**CCP24 Advice to Australian Energy Regulator on  
Australian Gas Networks Revised Final Plan  
for AGN Gas Networks (South Australia) Access Arrangement  
July 2021-June 2026**

**Consumer Challenge Panel (CCP) Sub-Panel CCP24**

**17 February 2021**

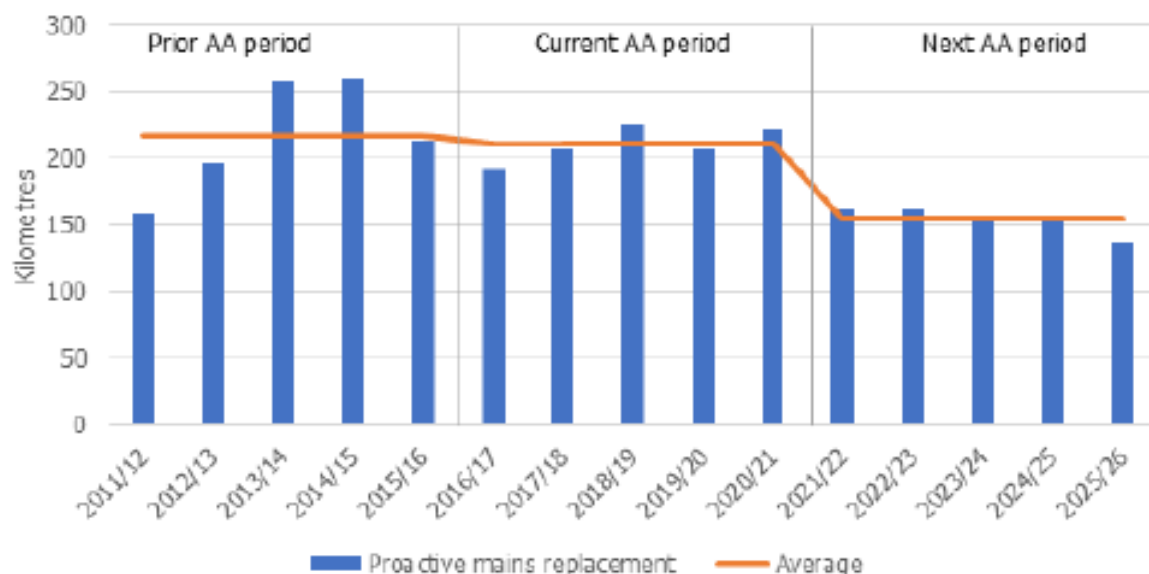
AGN says that in the current period they will replace 1052 kilometres of mains which they say is consistent with their commitments to both the OTR and AER. They also say that “Our revised Final Plan proposal will complete the replacement of all remaining high risk low pressure CI/UPS mains, another significant safety milestone for our customers and our business with the added benefit of:

The following chart has been provided by AGN showing this annual and regulatory period average mains replacement expenditure over the previous, current and next period

## Leak repairs on CI/UPS mains

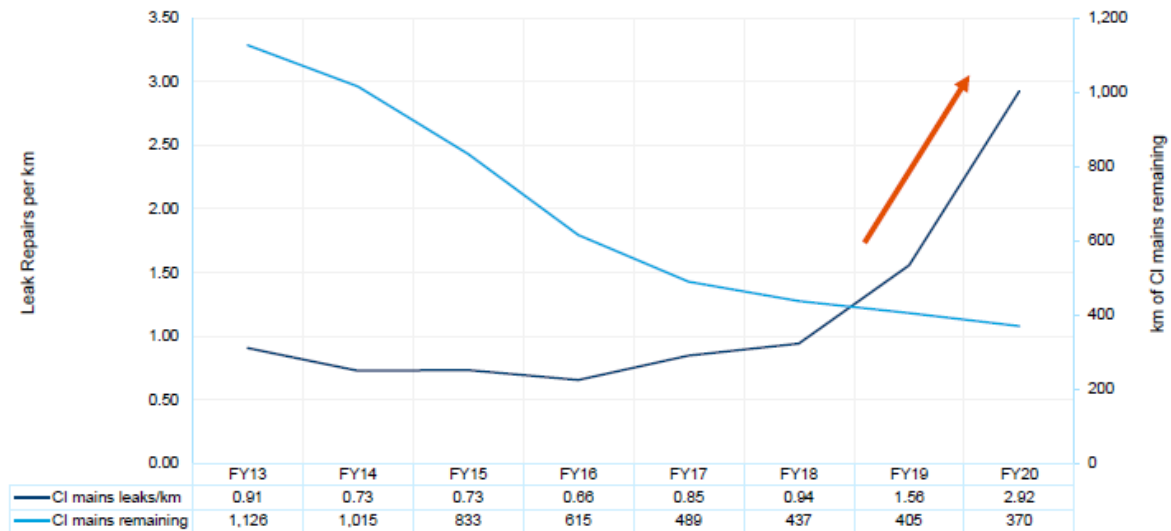
AGN has also provided the following graph which shows leak repairs on both cast-iron and UPS mains for financial years 2013 through to 2020. There has been a sharp increase in failure rates per

kilometre of mains over the last two years which AGN advises “correlates with the slowing of the CI/UPS block program in favour of HDPE replacement.”

AGN also advise that “the cheapest way to remove these mains is through block replacement.” This being in response to the suggestion that only the worst sections of mains need to be replaced. In other words, it is more cost-effective to replace the whole main, which can include cast-iron and polyurethane pipe, rather than just replacing the worst sections.

For us, the significant increase in leaks per kilometre over the past couple of years and the fact that the mains replacement program can be completed in the next regulatory period, at a lower rate of replacement than has occurred over the current period, lends weight to the AGN revised Final Plan proposal, which is less than their Final Plan and higher than the AER Draft Determination.
